CURTISS P-40
BULLETINS

TECHNICAL ORDER
No. 01-25C-7

CURTISS—OPERATION, MAINTENANCE, AND INSTALLATION INSTRUCTIONS FOR CARBURETOR AIR FILTERS—P-40E, P-40E-1, P-40K SERIES AND P-40M

Figure 4

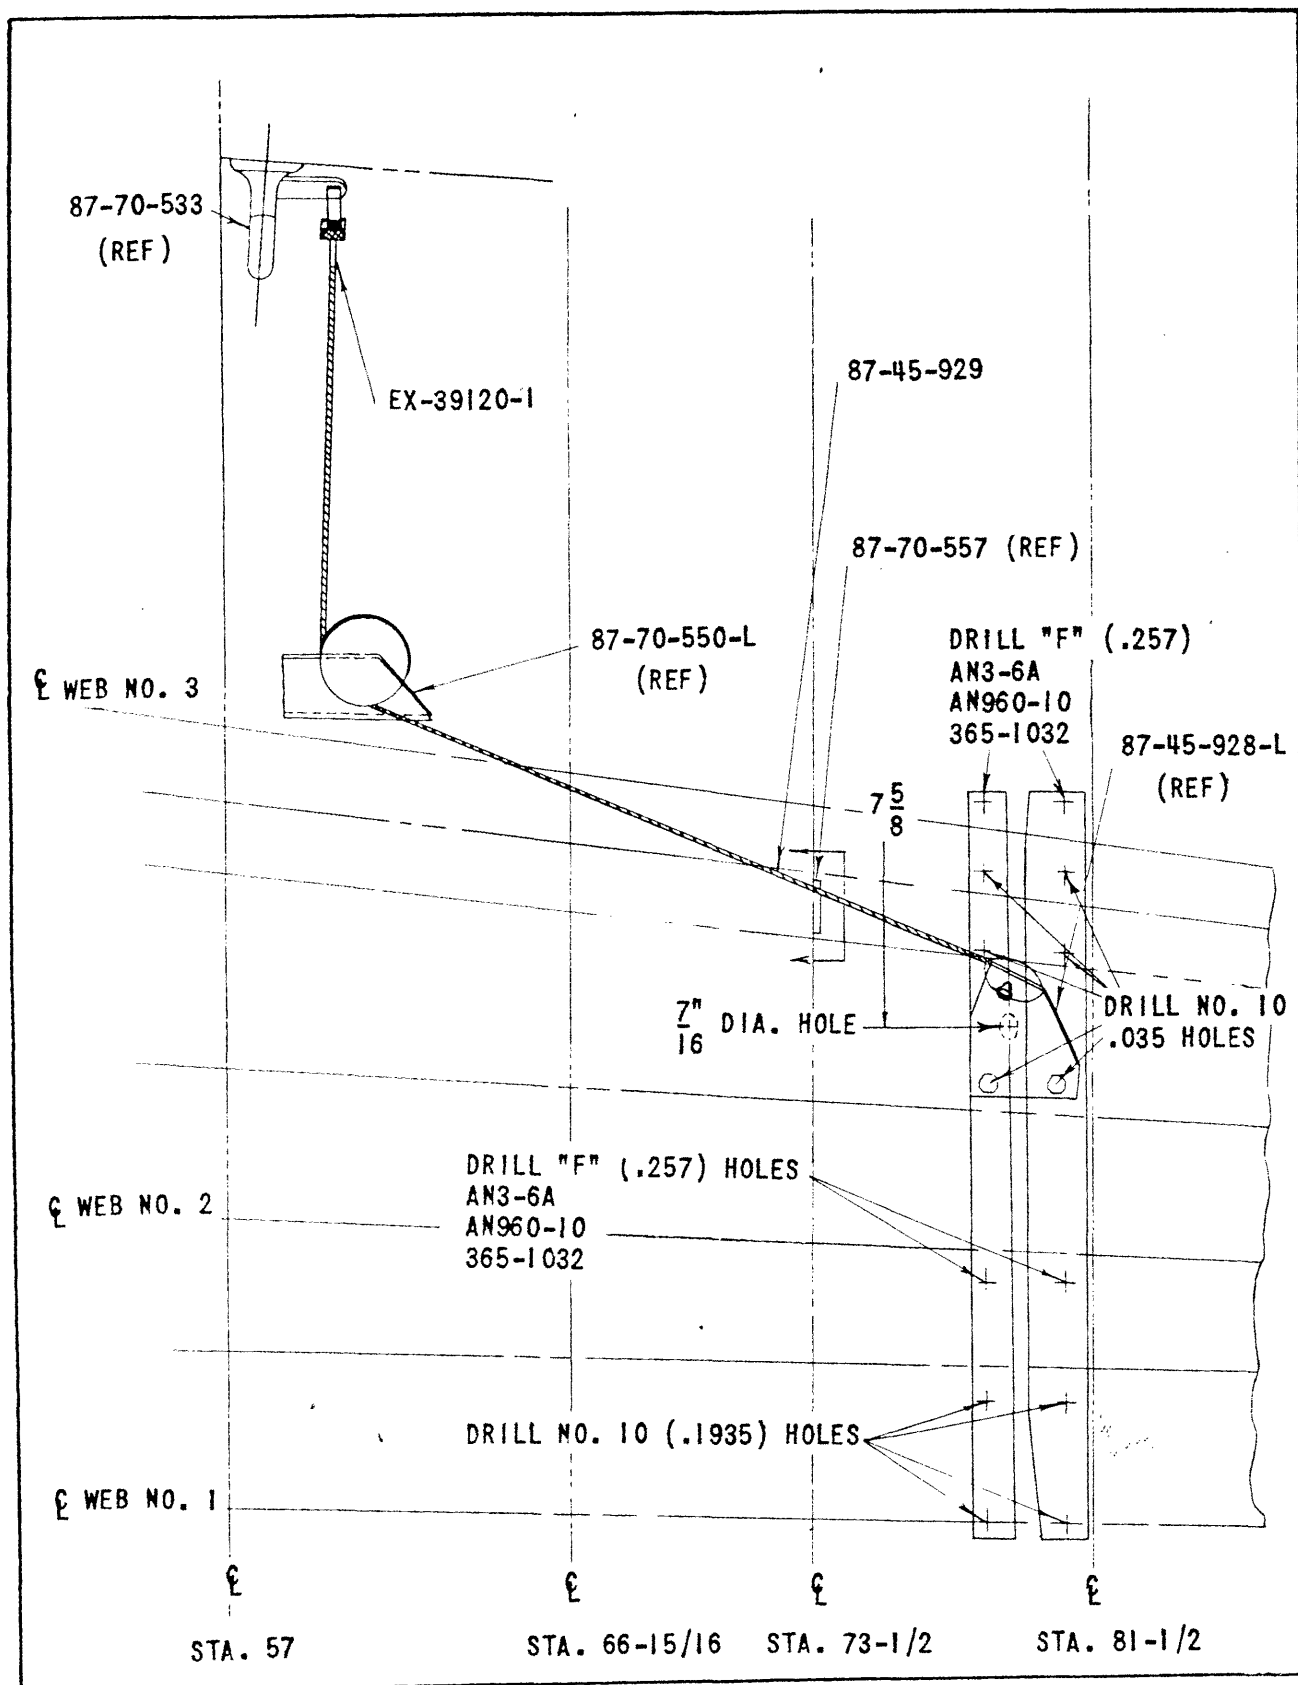
- d. Install a grommet, part No. AN931-16-22, in each hole.
- e. Locate and cut one 1-3/8 inch diameter hole in each gun access door. (See figure 2.)
- f. Locate and cut one 7/16-inch diameter hole in lower left and right panel skin. (See figure 4.)

- h. Locate and mark position of wing tank support, part No. 87-45-919, on wing. With care, drill four "F" (.257-inch) holes in panel to match holes lofted in support as shown in figure 4. Drill ten No. 10 (.1935-inch) holes in panel to match holes lofted in support. (See figure 4.)

p. Route cable, part No. 87-45-929, through center hole of fiber guide, part No. 87-70-557, and over pulley assembly, part No. 87-70-550, left and right. (See figure 4.)

q. Solder cable end assembly, part No. EX-39120-1, to end of cable and fasten to bell crank, part No. 87-70-533. (See figure 4.)

Figure 5

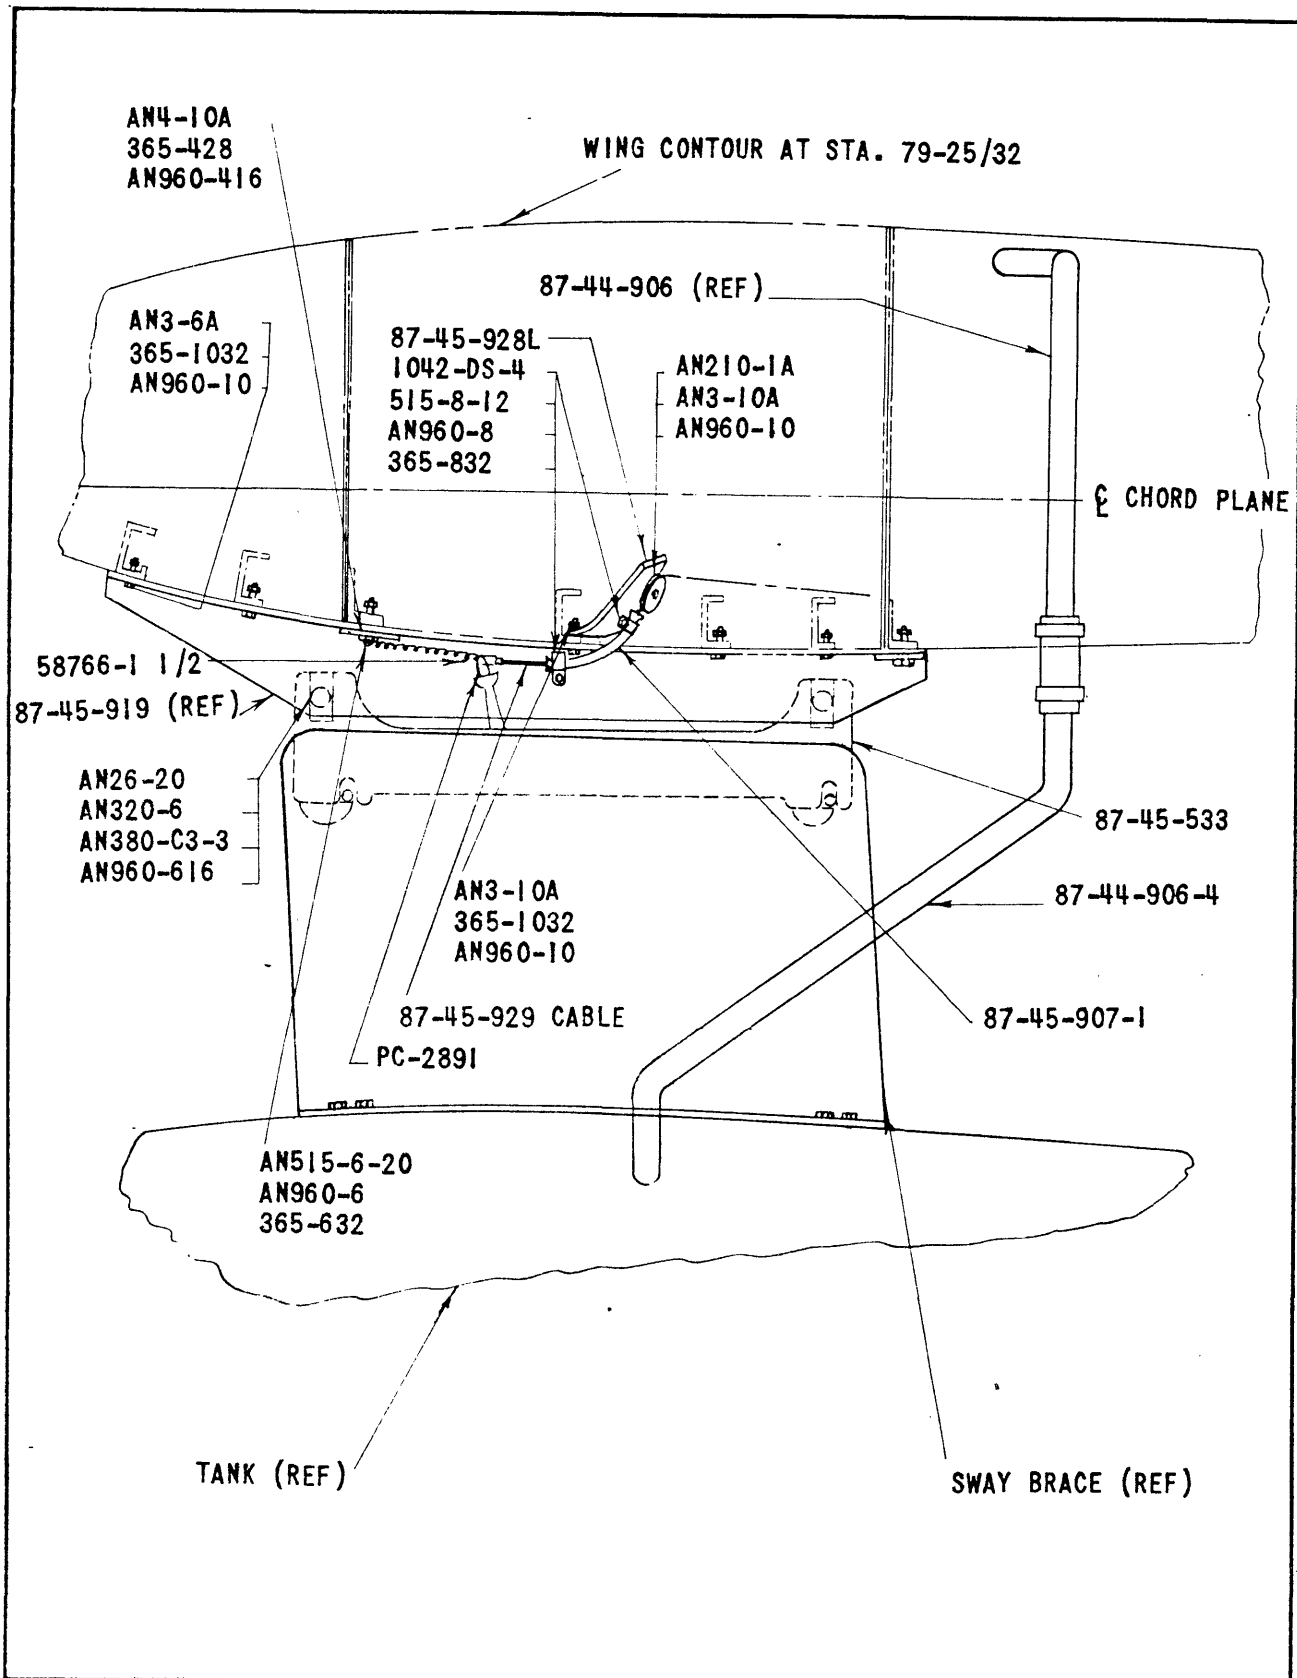
l. Using two each, bolt, part No. AN3-10A, washer, part No. AN960-10, and nut, part No. 365-1032, install bracket, part No. 87-45-928, left and right, in left and right panel with tube, part No. 87-45-907-1, projecting through 7/16-inch diameter hole. (See figure 5.)

m. Install spring, part No. 58766-1-1/2 (figure 5), using one each, screw, part No. AN515-6-20, washer, part No. AN960-6, and nut, part No. 365-632.

n. Install cable, part No. 87-45-929, to release arm of bomb release mechanism, part No. 87-45-553 (figure 5), using clevis pin, part No. PC2891, and route through tube, part No. 87-45-907-1, and over pulley, part No. AN210-1A, into gun compartment.

aw. Connect tube, part No. 87-44-906-4, to the hose, part No. 884-16-12, using one clamp, part No. FBA-14. (See figure 5.)

bw. Install tank. (See figure 5.)

Figure 6

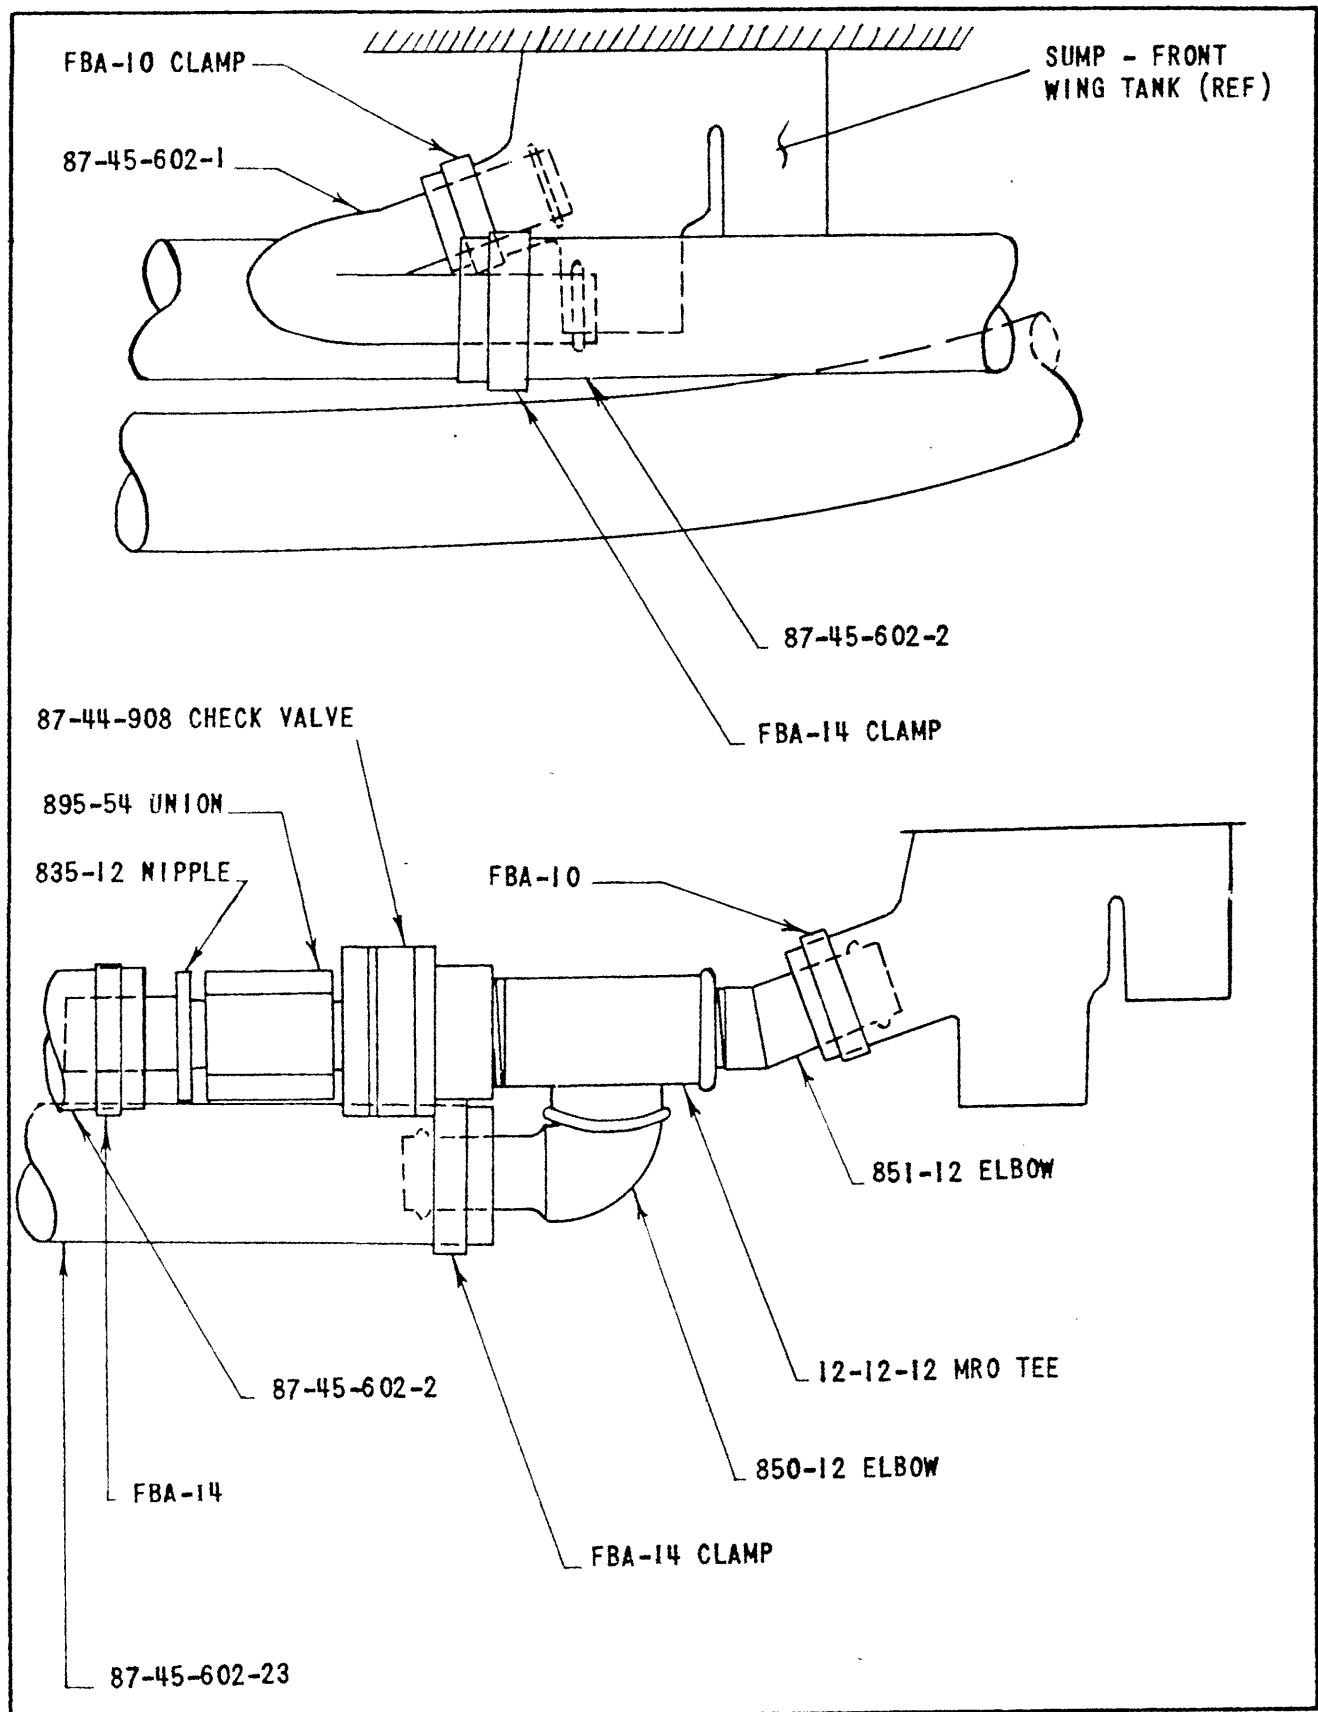
s. Assemble tee fitting, part No. 12-12-12-MRO, check valve, part No. 87-44-908, 45-degree elbow, part No. 851-12, 90-degree elbow, part No. 850-12, union, part No. 895-54, and nipple, part No. 835-12, as a unit. (See figure 6.)

u. Install tube, part No. 87-45-602-1, in the open port of the front wing tank sump (figure 6), using one clamp, part No. FBA-10.

v. Install hose, part No. 87-45-602-2, to tube, part No. 87-45-602-1, using one clamp, part No. FBA-14, at front tank sump and to nipple, part No. 835-12, at rear tank, using one clamp, part No. FBA-14. (See figure 6.)

Figure 7

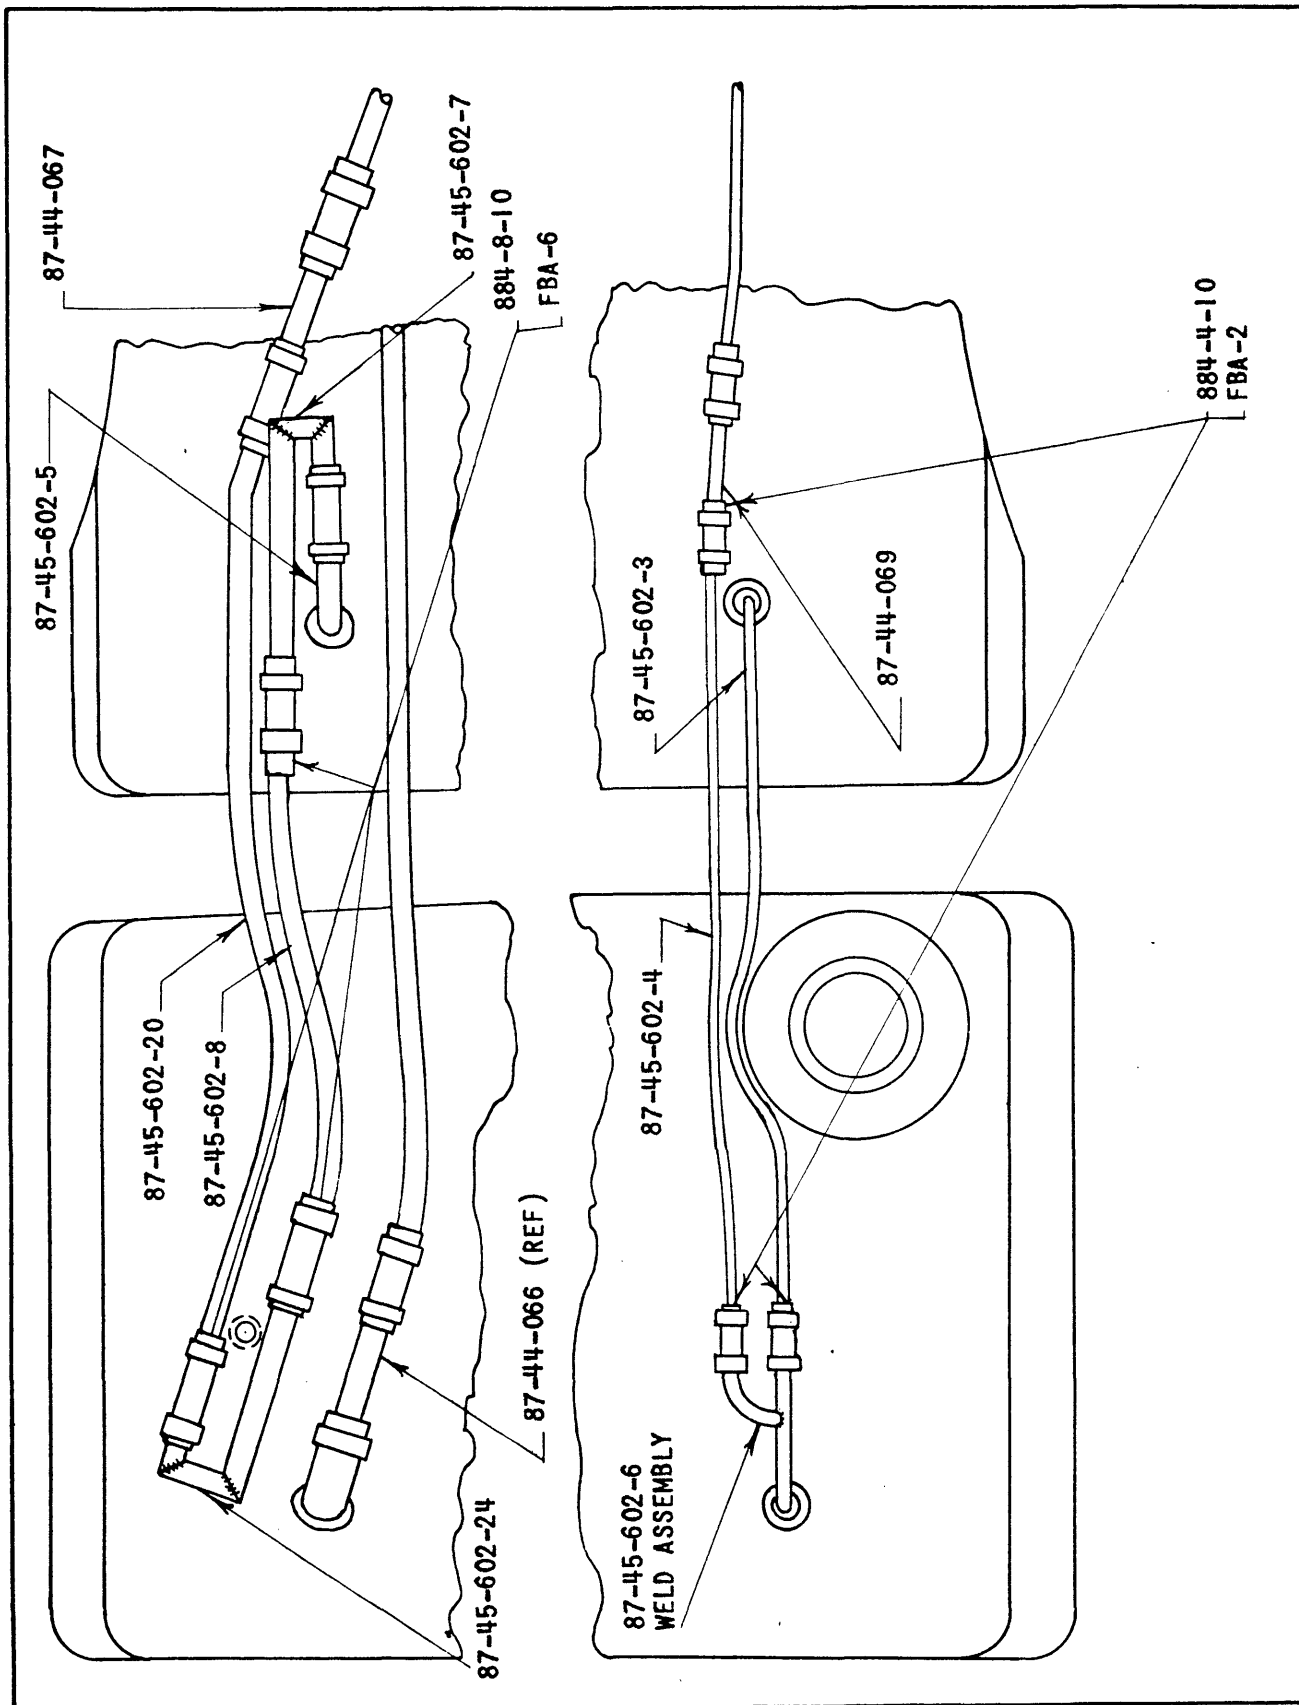
az. Install tube, part No. 87-45-602-3, in rear wing tank vent neck, using one clamp, part No. FBA-2, and to weld assembly, part No. 87-45-602-6, using one hose, part No. 884-4-10, and two clamps, part No. FBA-2. (See figure 7.)

ba. Connect tube, part No. 87-45-602-4, to weld assembly, part No. 87-45-602-6, using one hose, part No. 884-4-10, and two clamps, part No. FBA-2. (See figure 7.)

be. Connect weld assembly, part No. 87-45-602-7, to vent tube elbow, part No. 87-45-602-5 (figure 7), using one hose, part No. 884-8-10, and two clamps, part No. FBA-6.

bf. Connect tube, part No. 87-45-602-8, to weld assembly, part No. 87-45-602-7, using one hose, part No. 884-8-10, and two clamps, part No. FBA-6. (See figure 7.)

bg. Connect weld assembly, part No. 87-45-602-24, to tube, part No. 87-45-602-8, using one hose, part No. 884-8-10, and two clamps, part No. FBA-6. (See figure 7.)

bh. Connect tube, part No. 87-45-602-20, to weld assembly, part No. 87-45-602-24, using one hose, part No. 884-8-10, and two clamps, part No. FBA-6. (See figure 7.)

bi. Connect tube, part No. 87-45-602-20, to tube assembly, part No. 87-44-067, using one hose, part No. 884-8-10, and two clamps, part No. FBA-6. (See figure 7.)

bj. Connect tube assembly, part No. 87-44-067, to present existing vent line, using one hose, part No. 884-8-10, and two clamps, part No. FBA-6. (See figure 7.)

Figure 1 - Modification of Front and Rear Wing Fuel Tank and Filler Cap Adapters

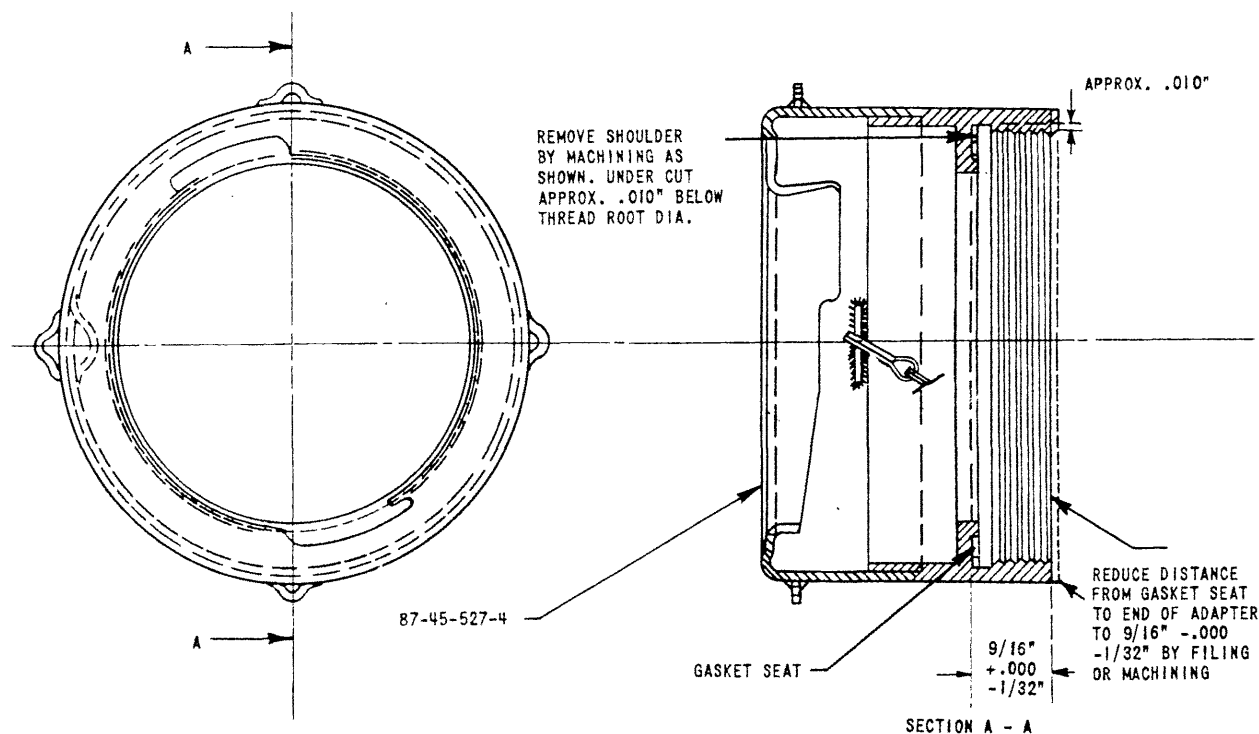
d. Rework front and rear adapter assemblies, as shown on figure 1.
